01-22-2026, REMOVED INTERIM COMPLETION DATE

MAH-680-4.58

PIER 3 CROSSFRAME REMOVAL AND REPLACEMENT
BRIDGE NO. MAH-00680-04.886
OVER PRICE ROAD & MILL CREEK

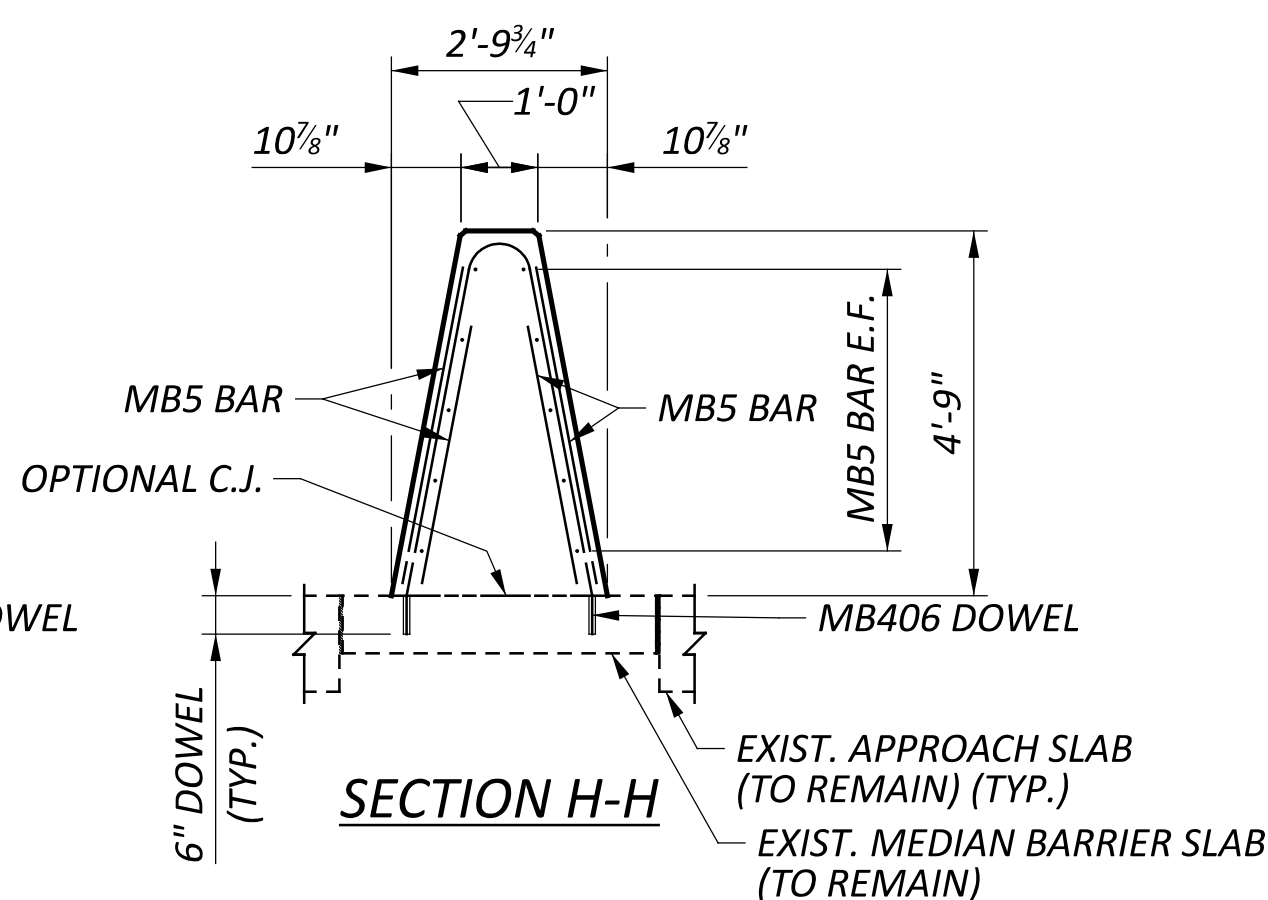
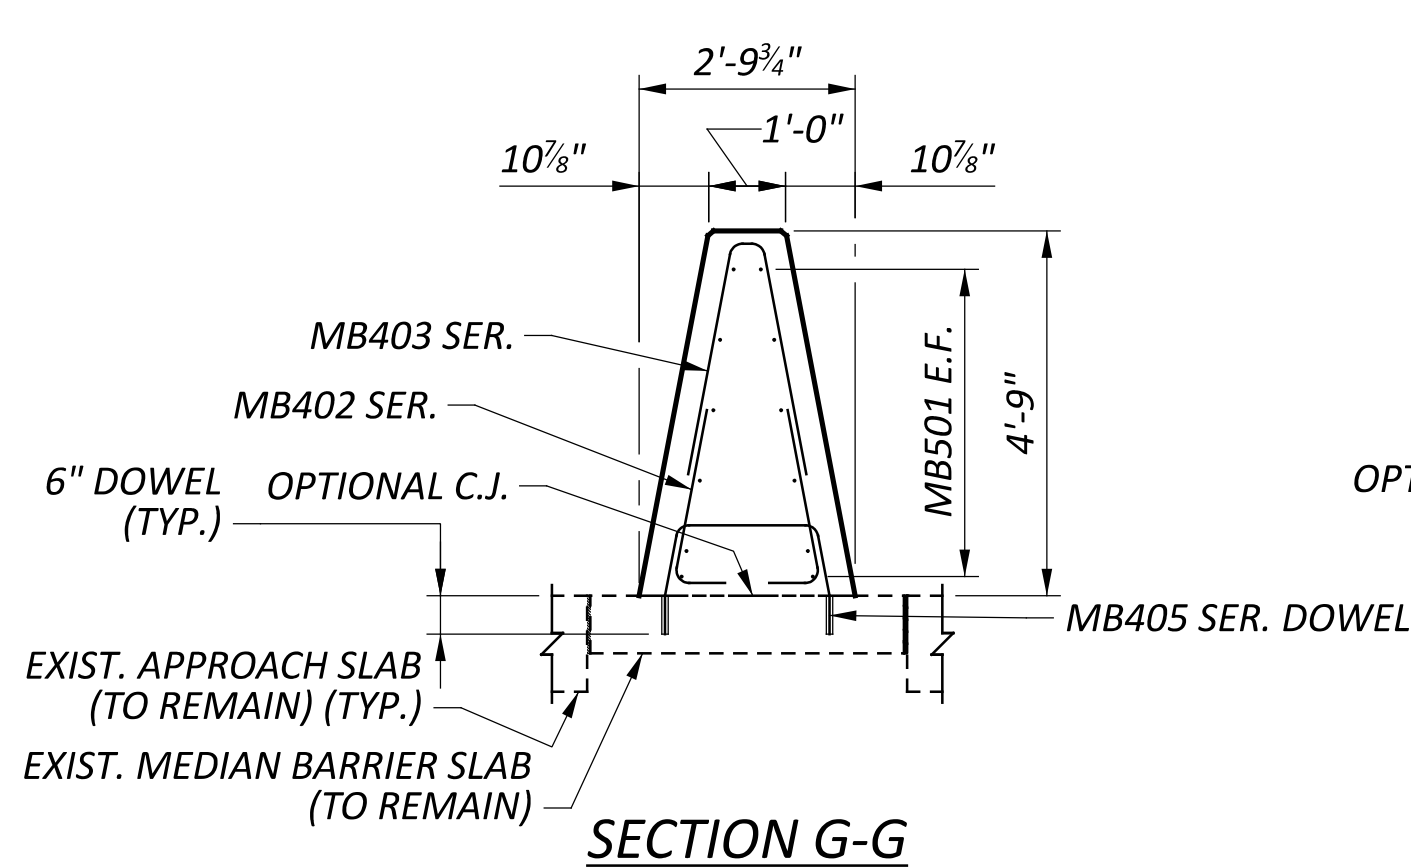
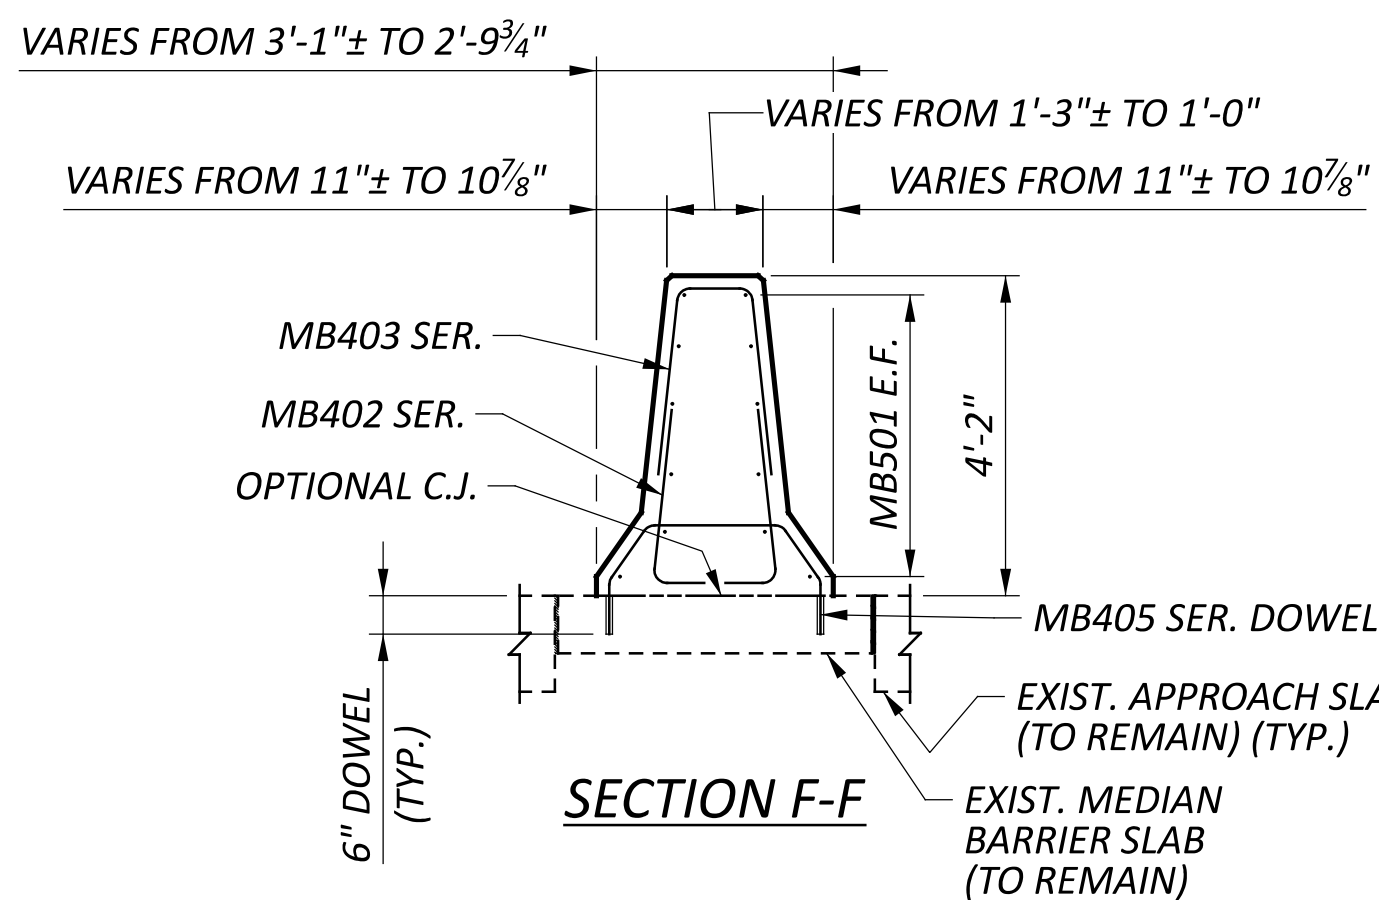
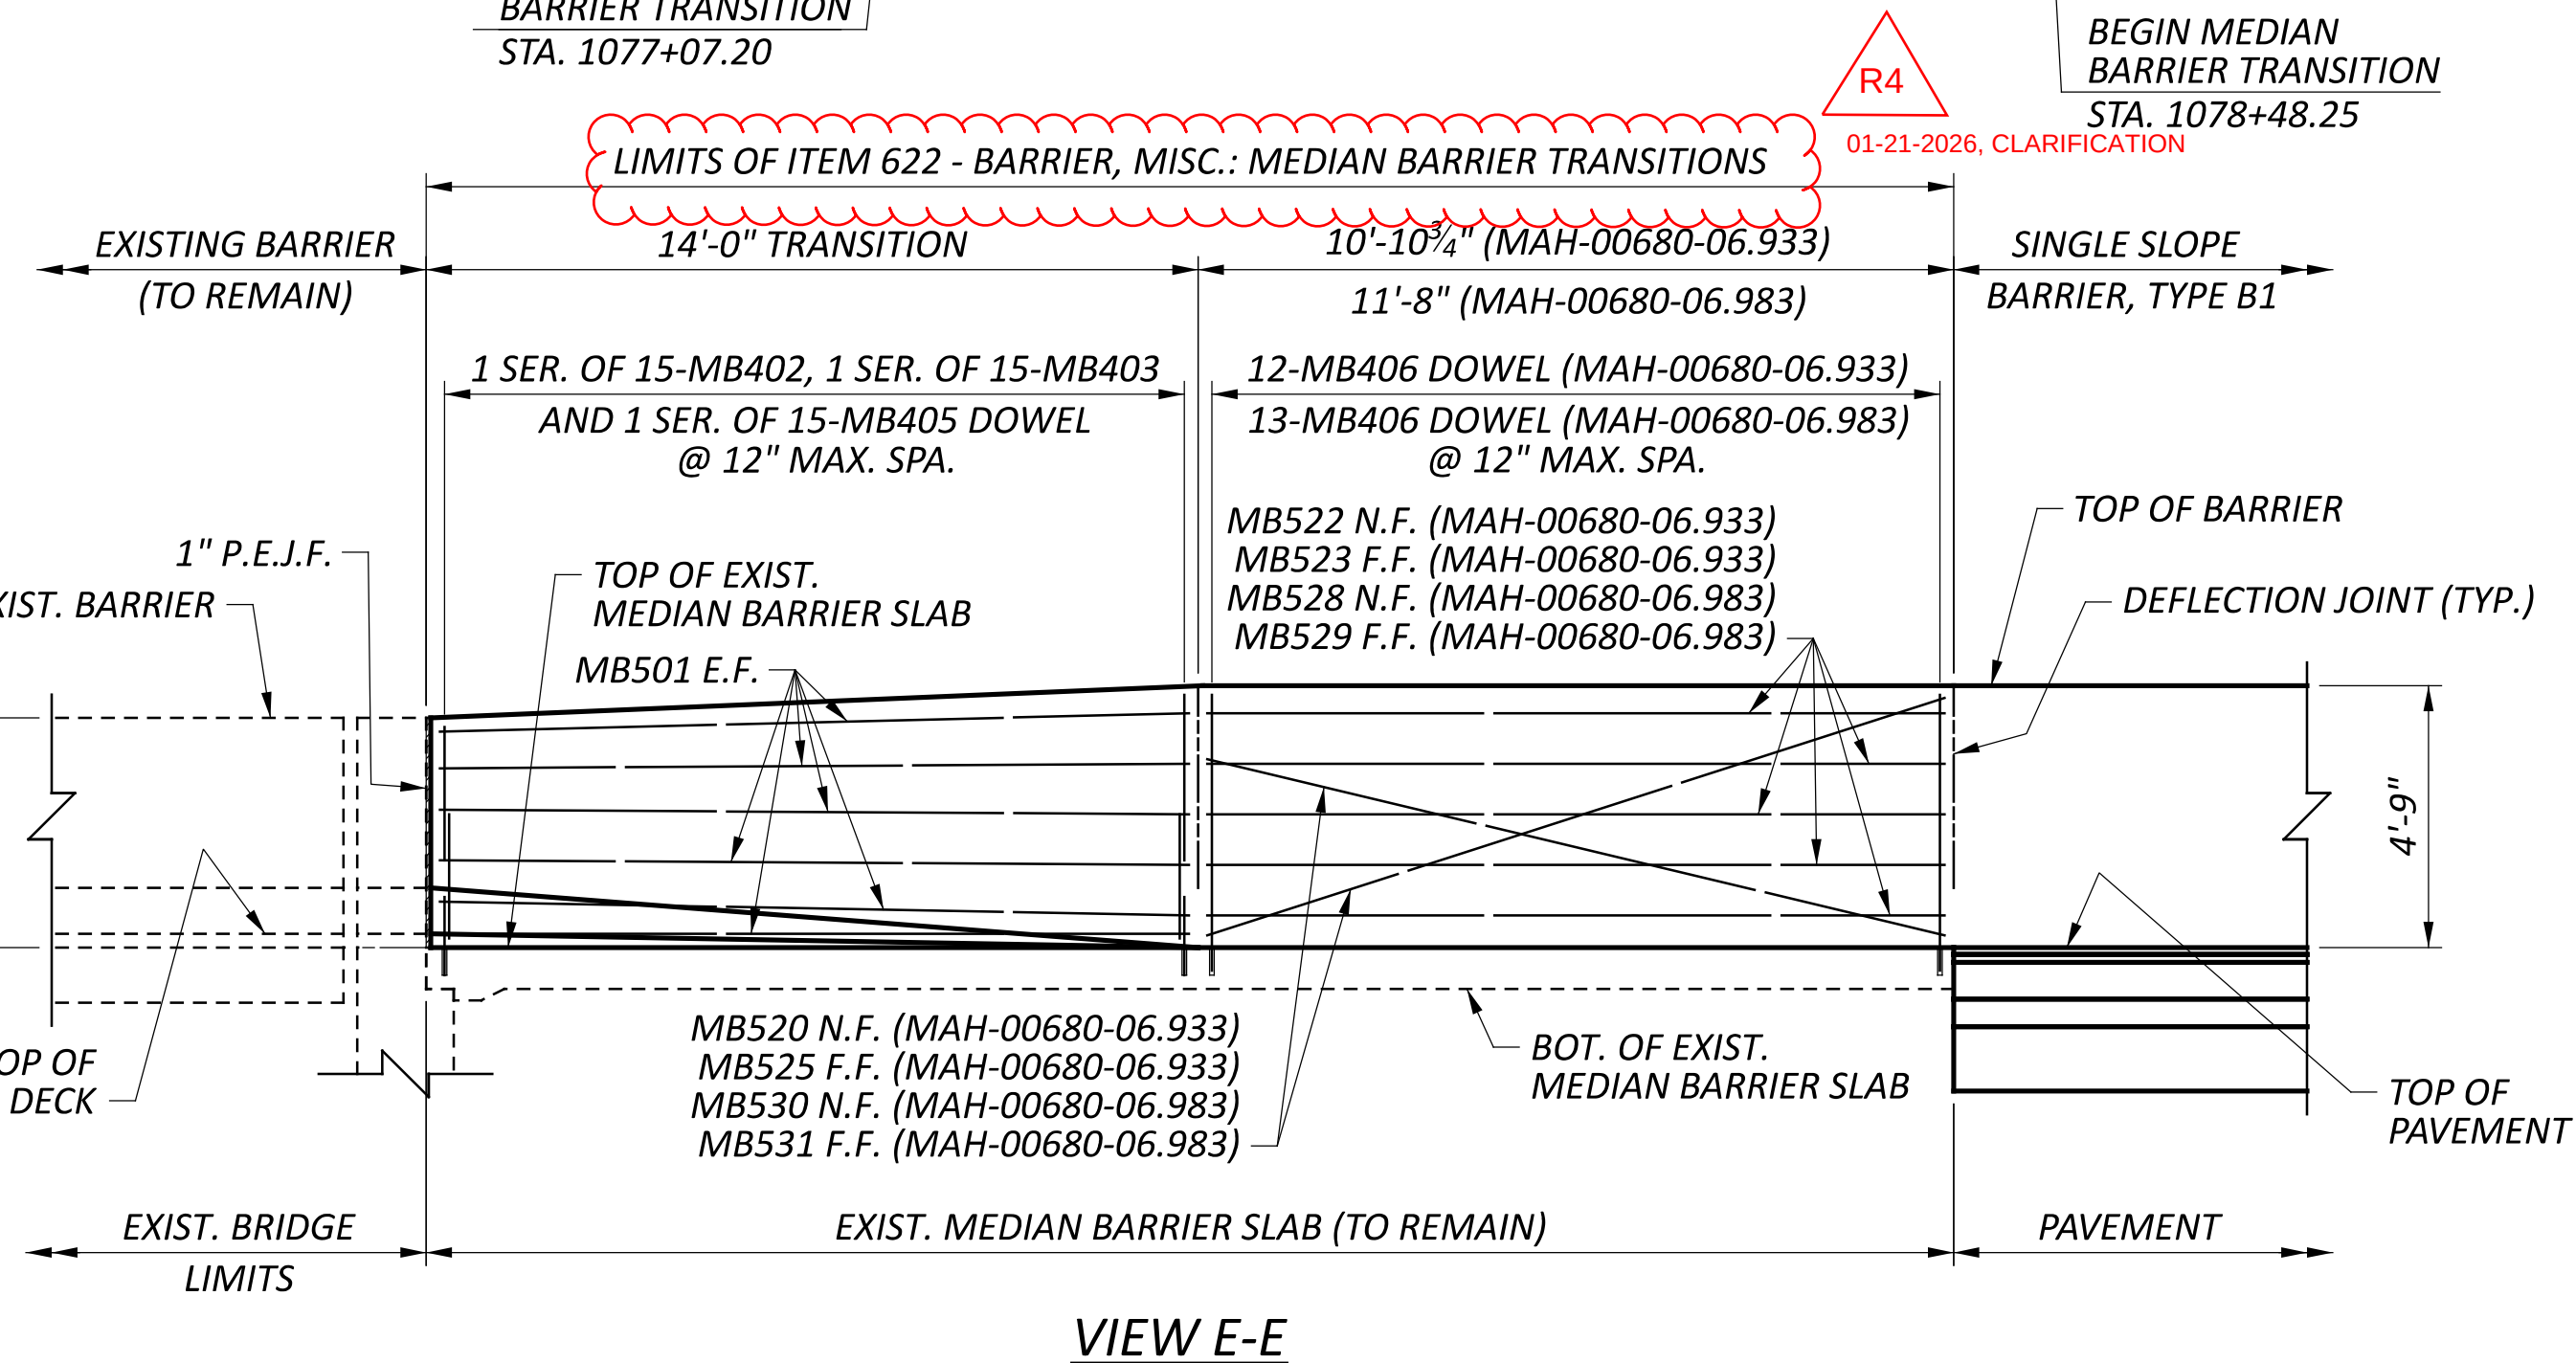
R4
 01-21-2026, CLARIFICATION

1. *FOR ADDITIONAL RAILING DETAILS, SEE STANDARD DRAWING SBR-2-20.*
2. *FOR REINFORCING STEEL LIST, SEE SHEET P.549/655.*
3. *PAYMENT FOR ALL LABOR, EQUIPMENT, MATERIALS AND INCIDENTALS NECESSARY TO FURNISH AND CONSTRUCT THE MEDIAN BARRIER TRANSITIONS SHALL BE INCLUDED WITH ITEM 622 - BARRIER, MISC.: MEDIAN BARRIER TRANSITIONS. REINFORCING STEEL, 1" P.E.J.F., CONCRETE, AND DOWELS SHALL BE INCIDENTAL TO THIS ITEM. A QUANTITY OF 110 FT HAS BEEN CARRIED TO THE GENERAL SUMMARY.*
